ITEM: 6.12	COMMITTEE OF ADJUSTMENT REPORT SUMMARY MINOR VARIANCE APPLICATION FILE NUMBER A145/23 435 CITYVIEW BLVD, WOODBRIDGE
-------------------	--

**COMMITTEE OF ADJUSTMENT REPORT
MINOR VARIANCE APPLICATION
A145/23
435 CITYVIEW BLVD, WOODBRIDGE**

ITEM NUMBER: 6.12	CITY WARD #: 3
APPLICANT:	435 Cityview Inc.
AGENT:	Brutto Consulting
PROPERTY:	435 Cityview Blvd, Woodbridge
ZONING DESIGNATION:	See Below
VAUGHAN OFFICIAL PLAN (2010) DESIGNATION:	Vaughan Official Plan 2010 ('VOP 2010'): "Prestige Employment"
RELATED DEVELOPMENT APPLICATIONS:	DA.22.078
PURPOSE OF APPLICATION:	Relief from the Zoning By-law is being requested to permit the development of a two-storey industrial/office building and to facilitate related Site Plan Application DA.22.078.

A1.01

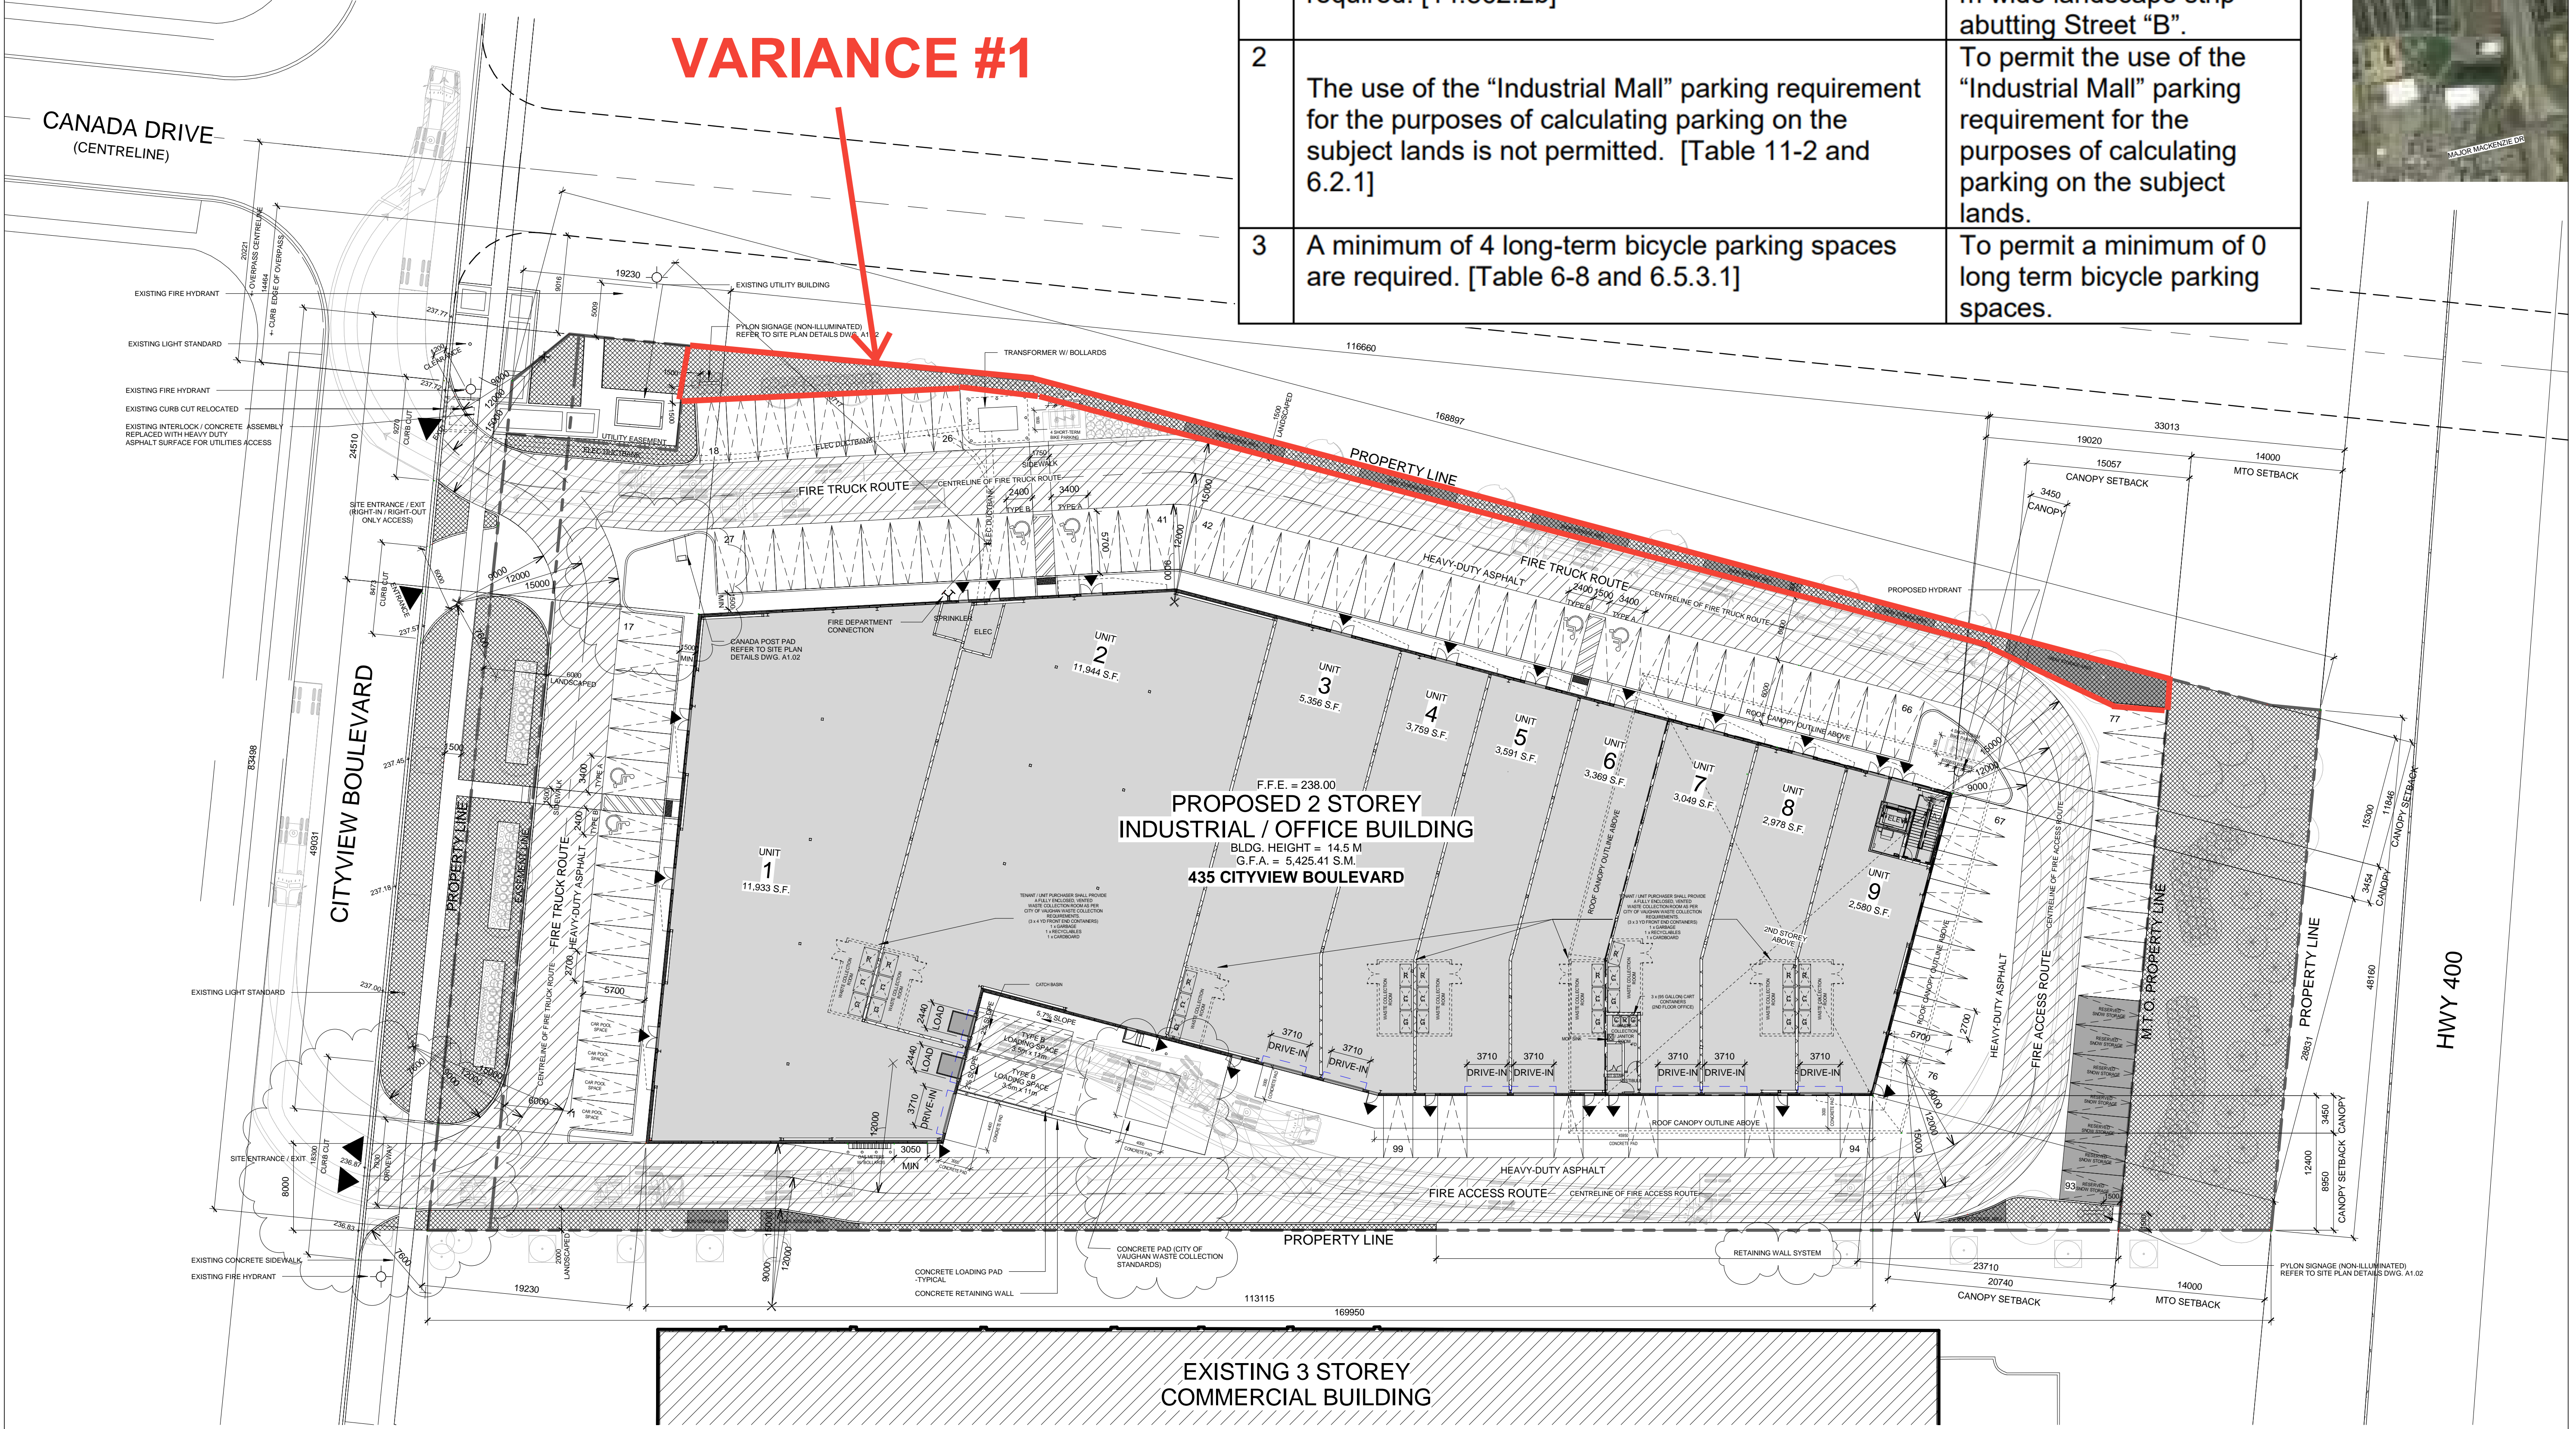
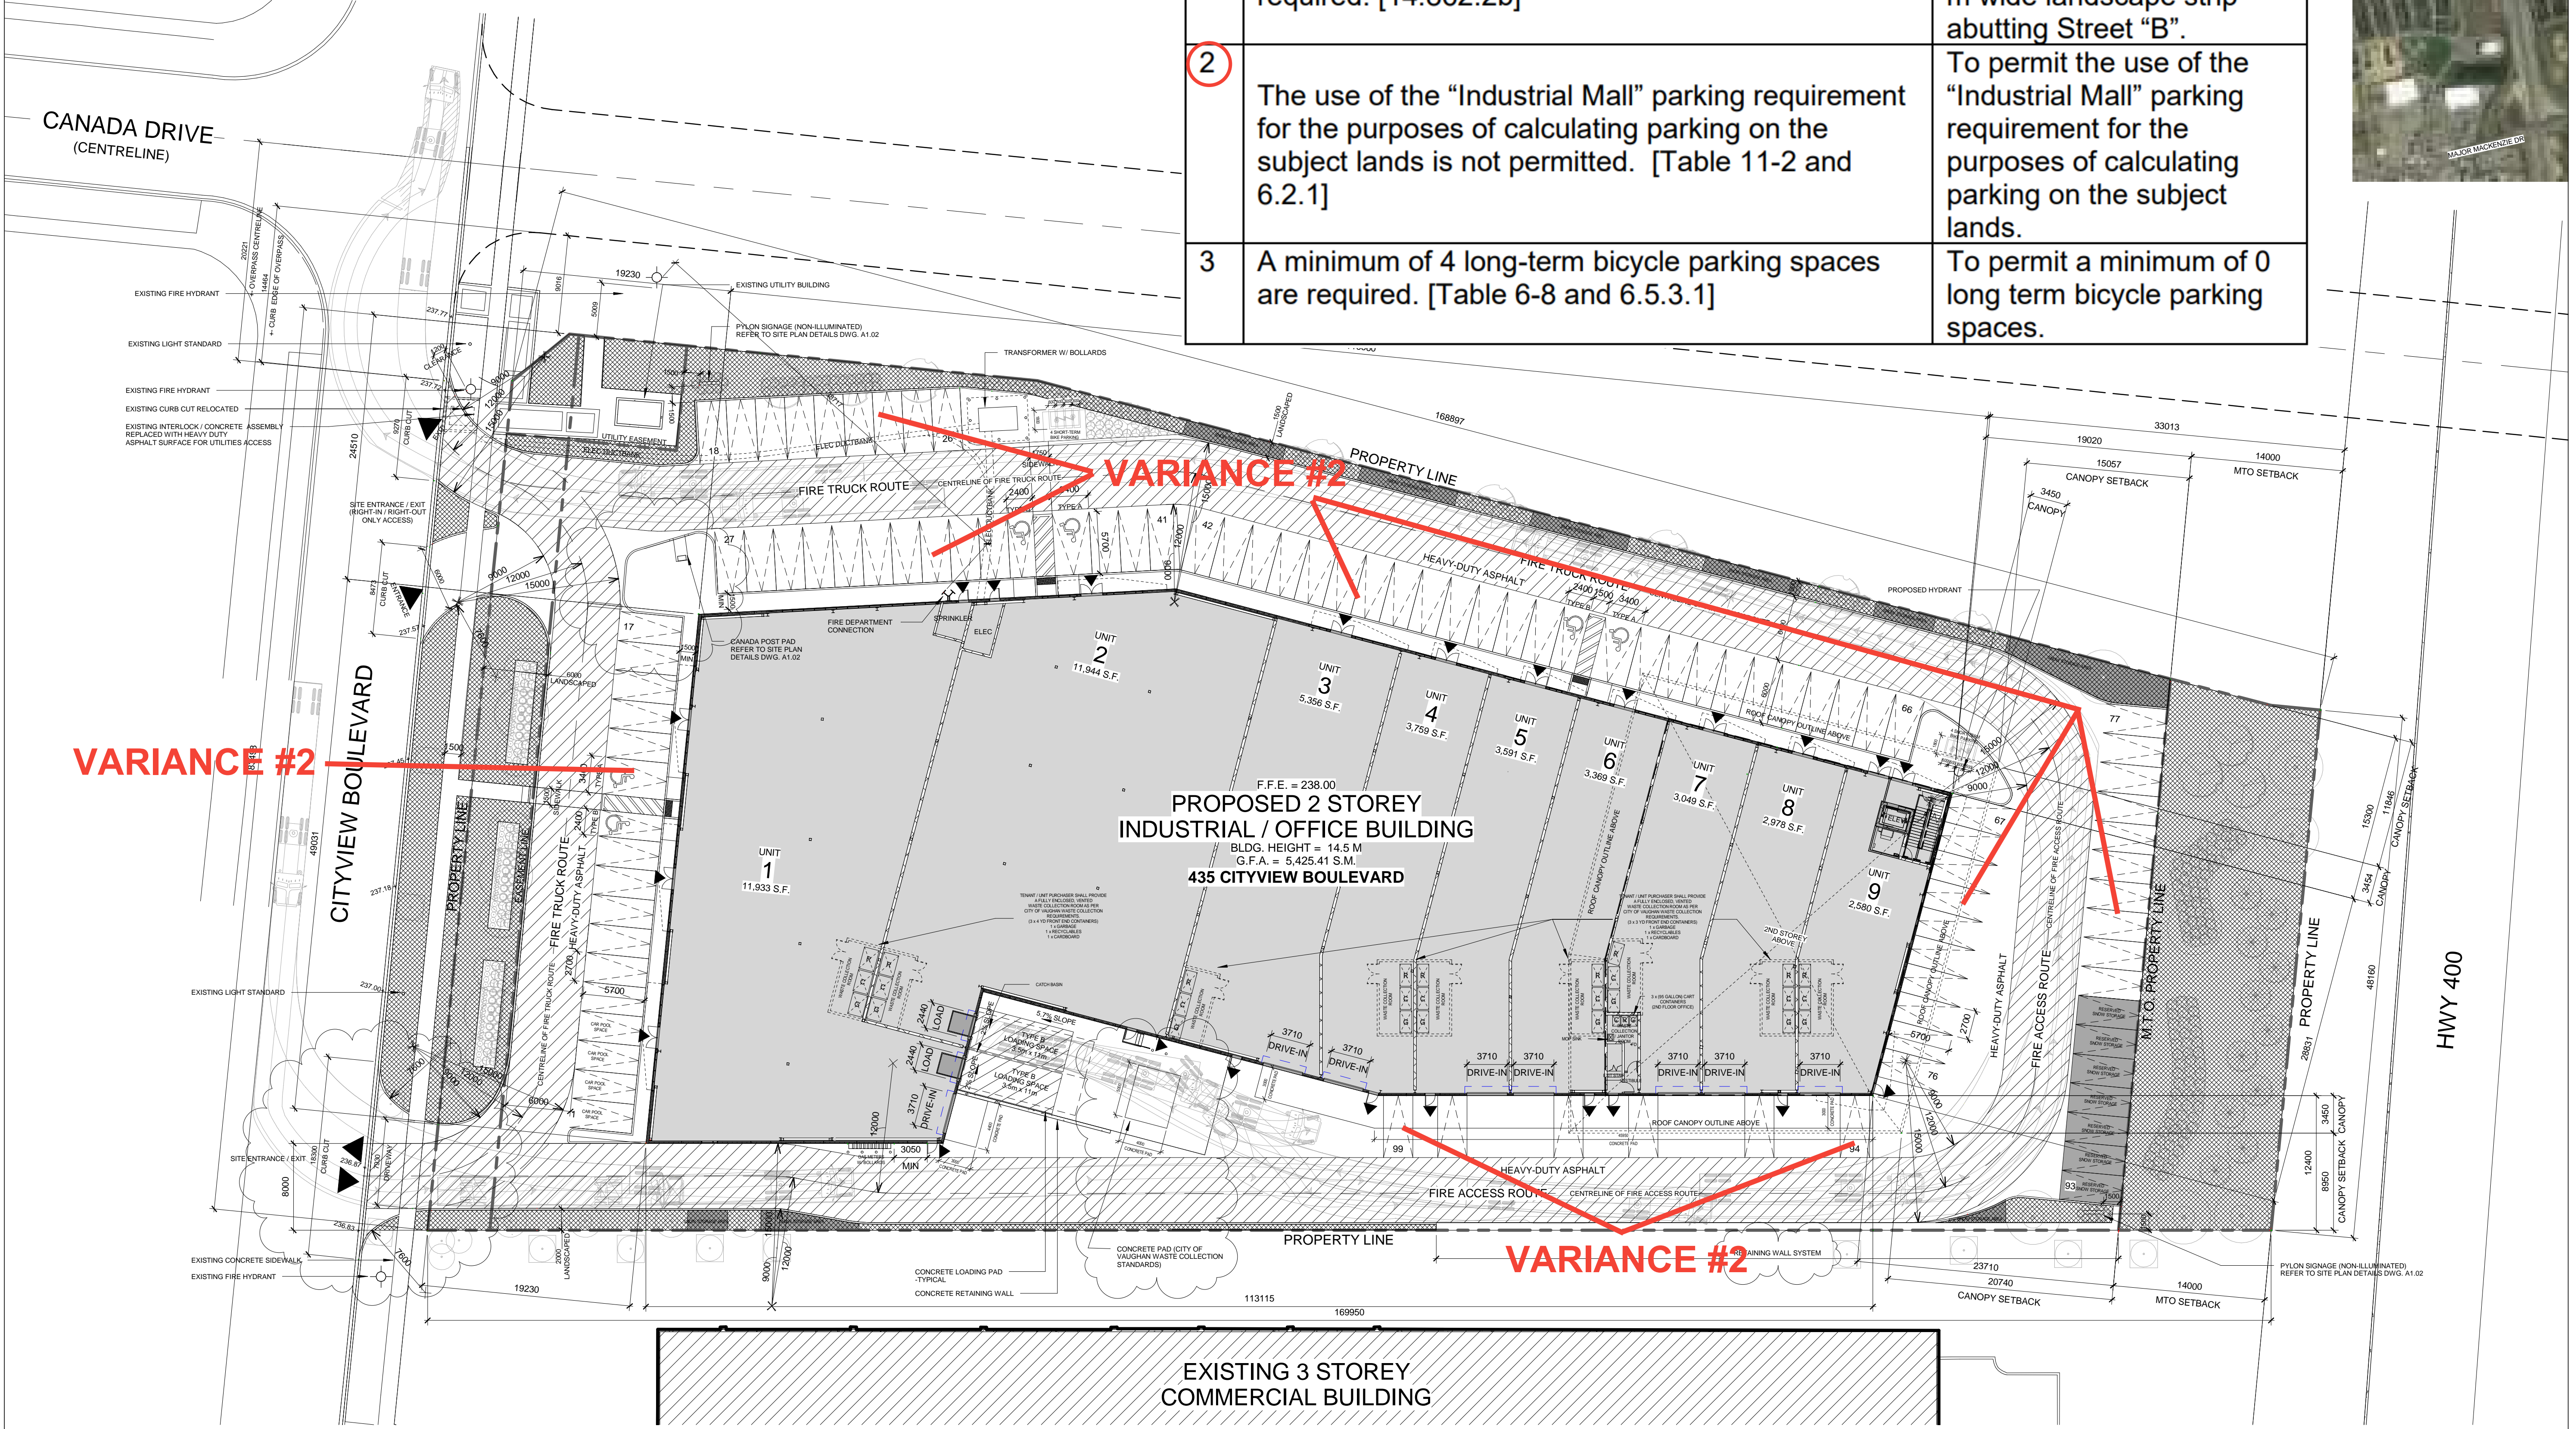
The Development Planning Department has no objection to Variance 1 to permit the proposed 1.5 m landscape strip abutting Street “B”. This requested variance was reviewed by Urban Design Staff through the supporting Site Development Application (File DA.22.078), who had no concerns with the proposed landscape strip width.

The Development Planning Department has no objection to Variance 2 to permit the use of the “Industrial Mall” parking requirement for the purposes of calculating parking on the subject lands. The proposed Standard Condominium tenure will allow industrial and commercial tenants to lease the units individually, similar to a shopping mall. Parking requirements for the individual units cannot be determined at this time, as the tenancy for the building has not yet been established. Applying the ‘Industrial Mall’ parking requirements to the subject lands allows for the application of a site-wide calculation as opposed to calculating the number of spaces required for the use in each unit. The subject lands are zoned “EM1 - Prestige Employment Zone” by Zoning By-law 001-2021 which does not permit an ‘Industrial Mall’. A recommendation from staff to permit the ‘Industrial Mall’ use within the EM1 Zone was adopted by Council on May 17, 2022, and is anticipated to go to a future Council Meeting for implementation as part of a general amendment. The proposed parking ratio will comply with Zoning By-law 001-2021 once the ‘Industrial Mall’ use is added to the EM1 Zone.

The Development Planning Department has no objection to Variance 3 to permit a minimum of 0 long-term bicycle parking spaces. The four (4) required long-term bicycle parking spaces will be provided but are to be accessed differently from what the by-law requires. The by-law requires the spaces to be located in a common area. The four largest units are proposed to have 1 space each. Therefore, the intent of the by-law to provide long term parking spaces at the correct number is being maintained. A condition is requested to ensure the parking is provided in light of the relief being sought.

1. That all comments including the provision of 4 long term bicycle parking spaces on Site Development Application DA.22.078, be addressed to the satisfaction of the Development Planning Department.
